Illinois Department of Transportation

SUBJECT: Rantoul National Aviation Center
Rantoul, Illinois
Champaign County
Illinois Project Number: TIP-4333
Contract No. RA015
Item No. 13A, June 12, 2015
Addendum B

NOTICE TO PROSPECTIVE BIDDERS

Reason for Addendum: In response to Contractor's questions, and for added clarification to the drawings and specifications, ITEM 401 BITUMINOUS SURFACE COURSE and drawing C1.03 RAMP REHABILITATION PLAN – BID ALTERNATE 1 are being replaced with the versions on the following pages.

RAMP REHABILITATION	
RAMP REHABILITATION PLAN - BID ALTERNATE 1	
project	contract
81158	RA015
drawing	rev.
C1.03	0
sheet 9 of 17 sheets	file 81158_C1.03_RAMP REHAB_ALT 1.DWG

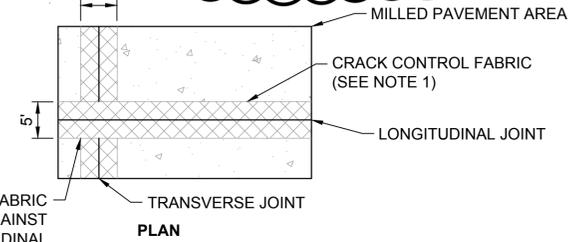
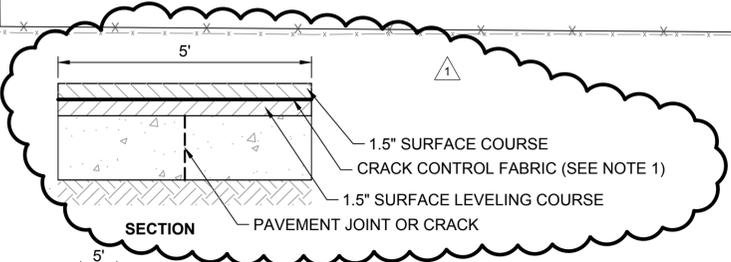
Revisions to the Construction Plan Sheets: Replace drawing C1.03 RAMP REHABILITATION PLAN – BID ALTERNATE 1 with the attached **Revised**, drawing C1.03 RAMP REHABILITATION PLAN – BID ALTERNATE 1.

NOTES:
1. CRACK CONTROL FABRIC SHALL BE PLACED OVER THE SURFACE LEVELING COURSE AND CENTERED ON LONGITUDINAL AND TRANSVERSE JOINTS/CRACKS. FABRIC OVER TRANSVERSE JOINTS/CRACKS IN PCC MUST BUTT UP TO, BUT NOT OVERLAP THE FABRIC PLACED OVER LONGITUDINAL JOINTS.

LIMITS OF PAVEMENT REMOVAL AND REPLACEMENT. NO FABRIC TO BE INSTALLED IN THIS AREA.

BID ALTERNATE NOTES:
1. IF BID ALTERNATE 1 IS AWARDED, CRACK CONTROL FABRIC SHALL BE PLACED ON LONGITUDINAL AND TRANSVERSE JOINTS WITHIN THE LIMITS SHOWN.
2. PAYMENT WILL BE MADE FOR WORK SHOWN ON THIS DRAWING UNDER ITEM AS201670.
